ELKO NEW MARKET - PLANNING COMMISSION MEETING

**MINUTES
CITY OF ELKO NEW MARKET
PLANNING COMMISSION MEETING
March 6, 2018
7:00 PM**

TO: PLANNING COMMISSION
CC: BJORN VOGEN, RAV HOLDINGS & GRANT JACOBSON, JACOBSON ENGINEERS & SURVEYORS
FROM: RENEE CHRISTIANSON, COMMUNITY DEVELOPMENT SPECIALIST
RE: REQUEST FOR AMENDMENT TO APPROVED PUD #5, AMENDING THE APPROVED LAYOUT FOR EXISTING OUTLOT B TO INCLUDE 11 SINGLE-FAMILY LOTS AND AMENDING THE APPROVED LAYOUT FOR OUTLOT A TO INCLUDE 8 SINGLE-FAMILY DETACHED TOWNHOME LOTS.
REQUEST FOR PRELIMINARY AND FINAL PLAT APPROVAL OF BOULDER POINTE SEVENTH ADDITION, AS PROPOSED BY RAV HOLDINGS, LLC
DATE: JUNE 1, 2017

Date: March 9, 2018
To: Renee Christianson, Community Development Coordinator
From: Rich Revering, PE – City Engineer
Subject: Review of Grading Drainage and Utility Plan – Boulder Pointe 7th Addition
Elko New Market
Project No.: T17.115956

BOULDER POINTE
 TYPICAL LANDSCAPE PLAN (VERIES W/ MODEL)
 1692 # SHOWN

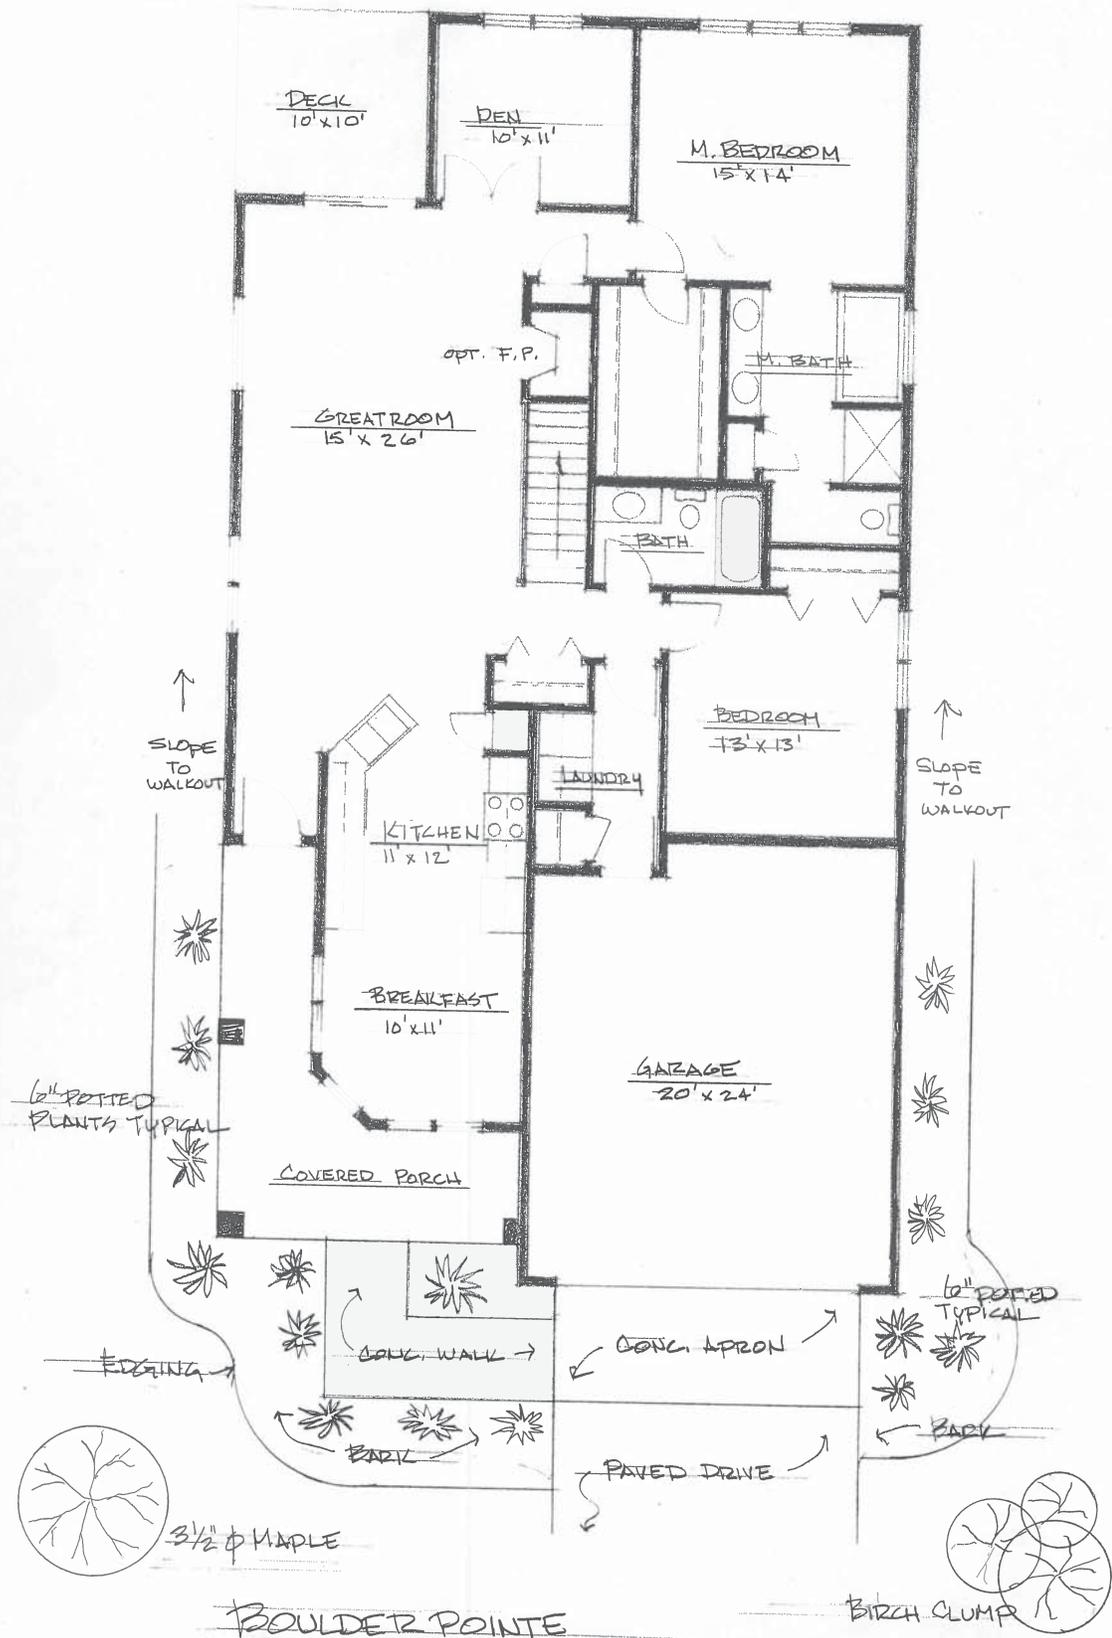
As part of the 2009 PUD, a “typical” landscape plan was approved. The landscape plan calls for sixteen unspecified potted plants (6”) around the front and sides of the units, a 3 ½” maple tree and a birch clump.

The developer would like to remove this currently approved drawing from the approved plan set, and instead, describe any landscaping obligations by adding a text description of the requirements. The reason for this request is because the home designs will not all be the same. There is design flexibility so not all homes and front entrances will look the same.

Staff supports the requested approach. Staff suggests the approved landscaping plan (drawing) be removed from the approved plan set and the following language be added as a condition of approval in regards to landscaping:

“Each home shall be required to have landscape plantings around the front of the home and in the front yard. Each home shall plant a minimum of three shrubs, ten 6” potted plants, and two trees in the front yard. Trees shall be a minimum of 2 ½ ” diameter deciduous trees or minimum 6’ high coniferous trees. Allowable tree species shall be as allowed in the City Code. All landscaping shall comply with applicable landscaping requirements of the City Code.”

Exhibit E – Plans dated 3/2/18

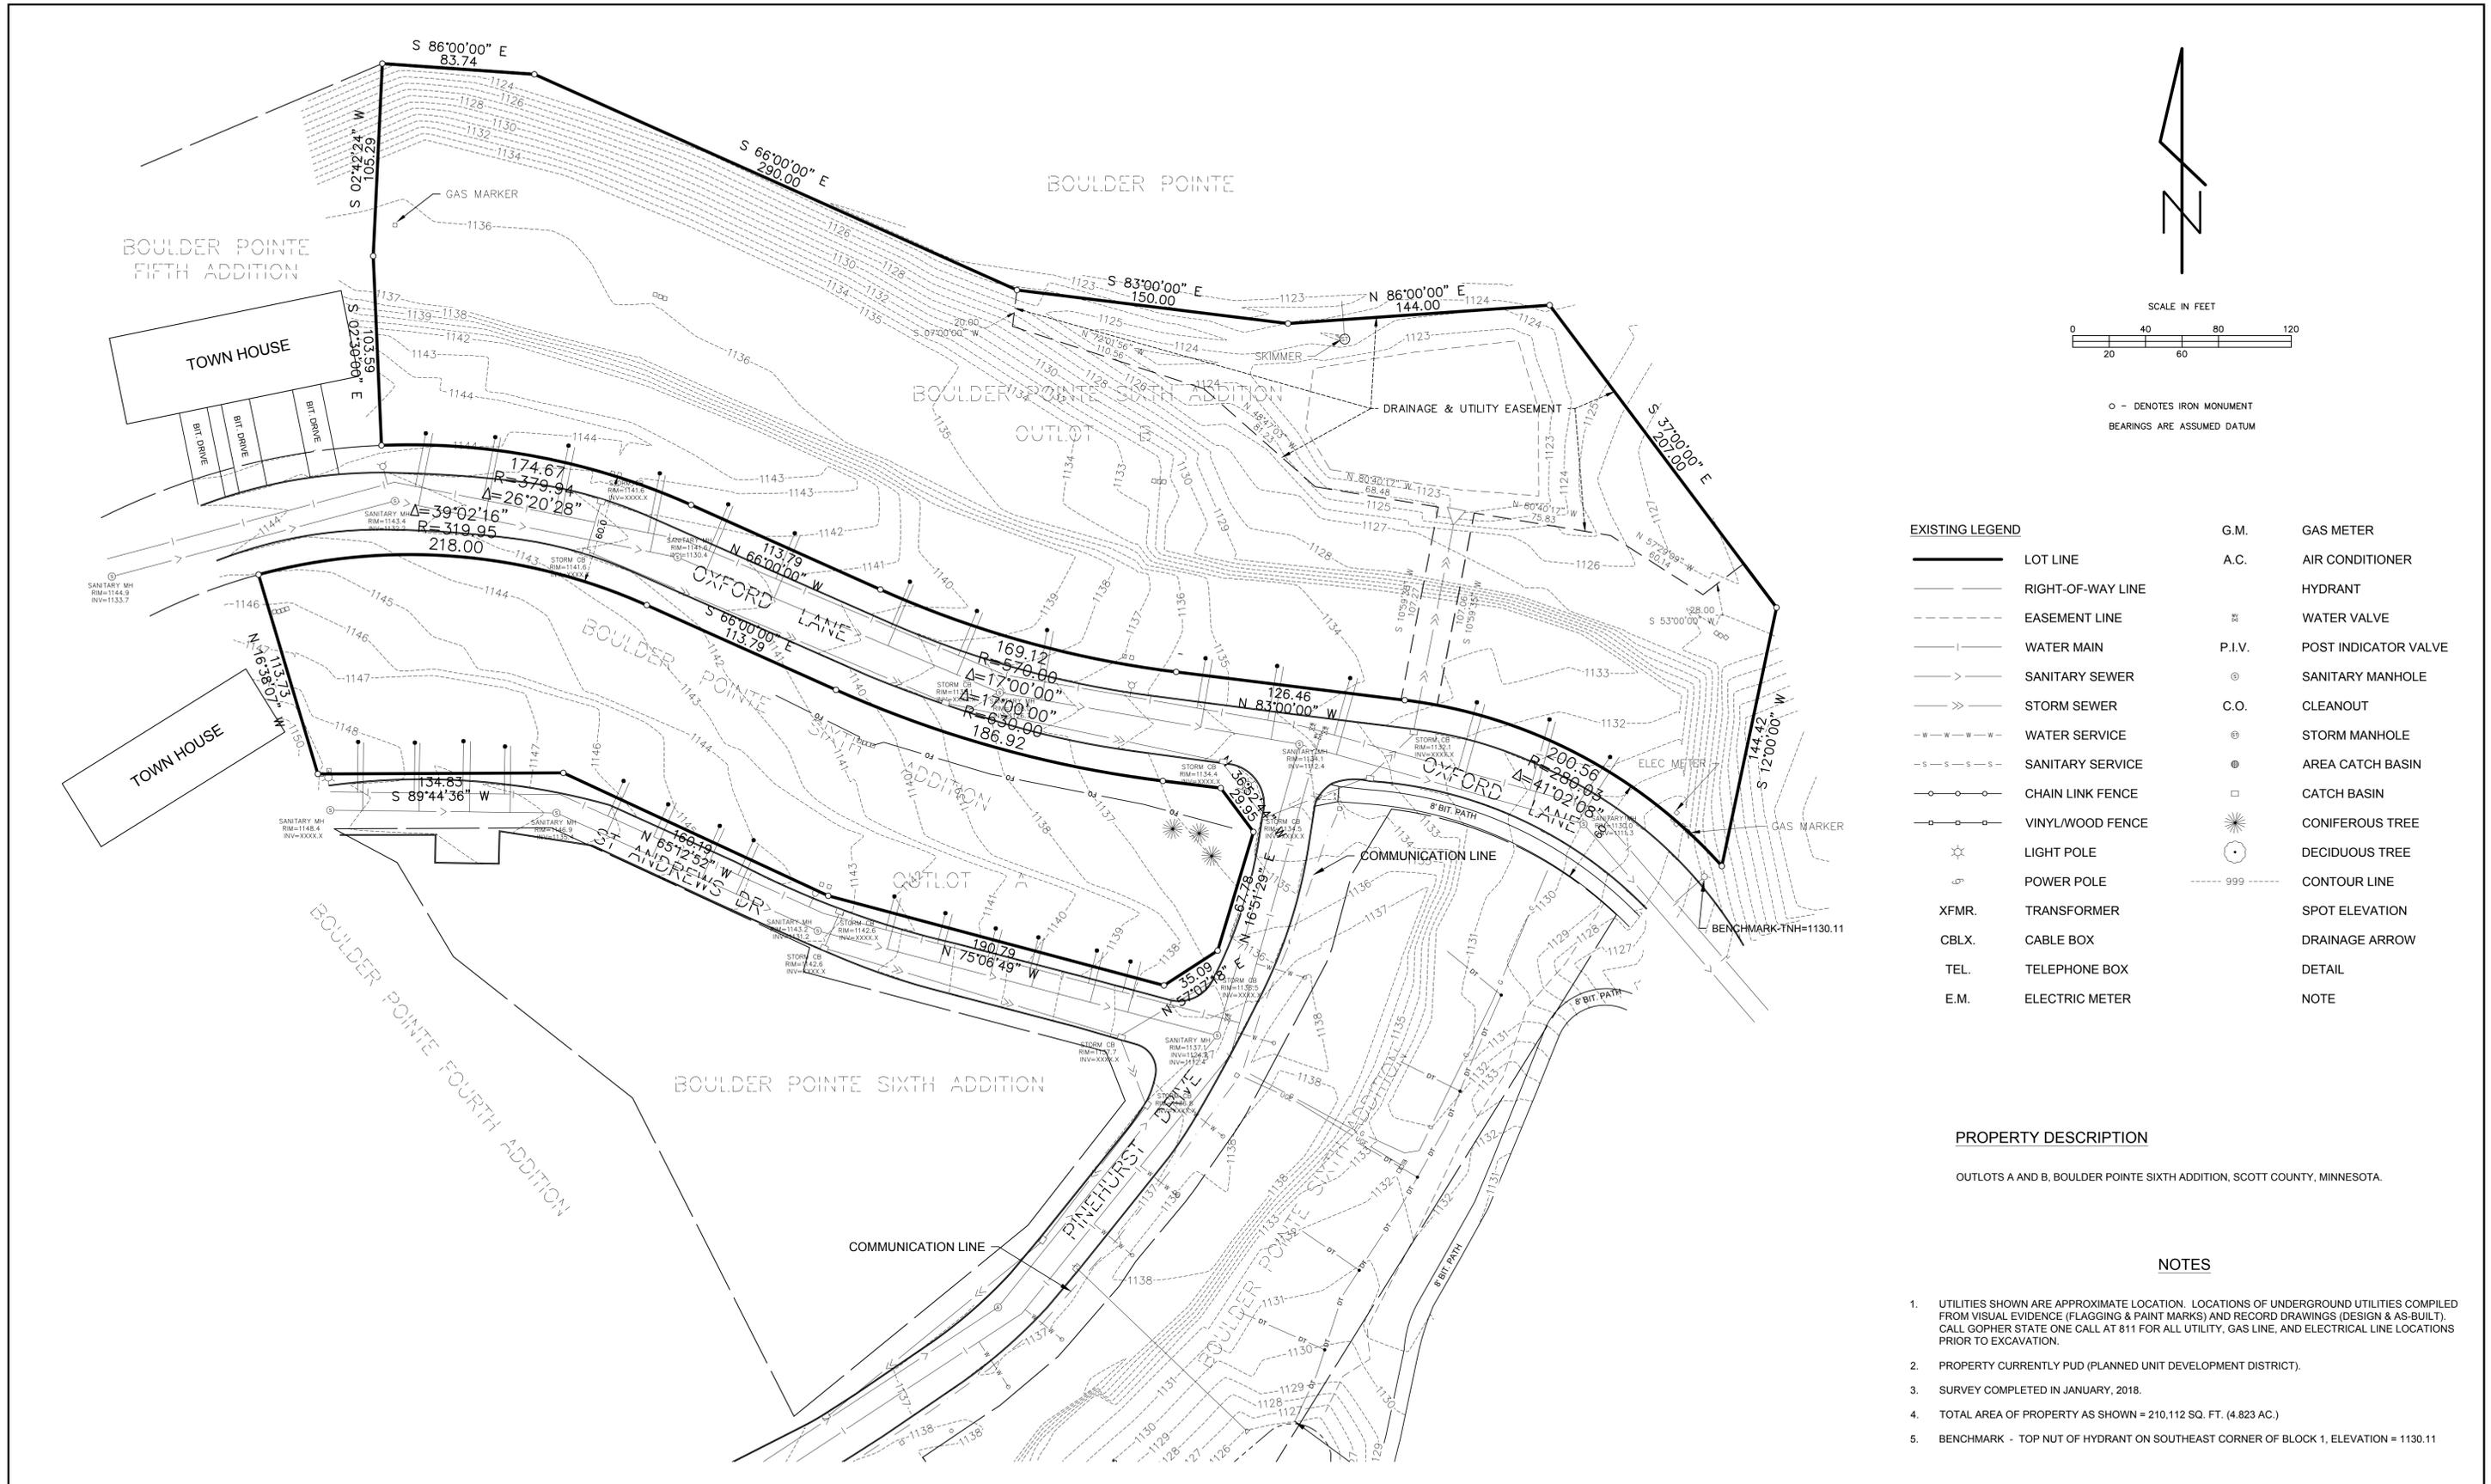
The plans submitted with the application dated March 2, 2018 depict varying setbacks depending on the individual lot configuration and width. The plans also depict a specific home footprint for Block 1, and another specific home style for Block 2. Staff would suggest, rather than approving the very specific setbacks as depicted on the March 2, 2018 drawings, that the City consider approving standard setbacks for each block. Staff suggests 5' on one side and 10' on the other, and requiring a minimum of 15' between each building. Staff suggests a 25' front setback for Block 1 and a 20' front setback for Block 2. Staff notes the following concerns with the setbacks drawings submitted:

Section 12-9-6 of the Subdivision Ordinance requires that 10’ wide perimeter easements and 5’ wide interior easements be dedicated along all lot lines. The final plat drawing submitted complies with the Subdivision Ordinance in this regard, except on proposed Lots 1 & 11 Block 1, and Lot 1 Block 2, where 5’ perimeter easements are proposed rather than the required 10’. Staff suggests that the drawings be amended to show 10’ perimeter plat easements on Lots 1 & 11 Block 1, and Lot 1 Block 2. **Note: this will affect the proposed building envelope on Lot 1 Block 1 and Lot 1 Block 2.

- 6) The drawings must be revised to show 10’ wide perimeter easements on Lots 1 and 11, Block 1 and Lot 1 Block 2.
- 7) The sanitary sewer and water service line serving proposed Lot 7 Block 1 should have a direct route from the right-of-way into the lot. If the service lines cross another lot in any fashion, an easement will be needed across that portion of the adjacent lot covering the route of the sewer and water lines.

- 8) Unused sanitary sewer and water stubs must be clearly identified in the field.
- 9) The construction plans must be revised to include a rear-yard drain tile system and tile connection stubs that can be used for sump pump connections.

- 10) The construction plans should be revised to show the normal and high water level of the existing stormwater pond.
- 11) The plans must be revised to show the stormwater pond located within an outlot, to be dedicated to the City.

- Driveways, especially on St. Andrews Drive, appear to be 20 feet or less from the property line/curb. Longer vehicles or vehicles with accessories or trailers may encroach into the roadway, posing a hazard or obstructing traffic. Refer to Planning comments for required setback.
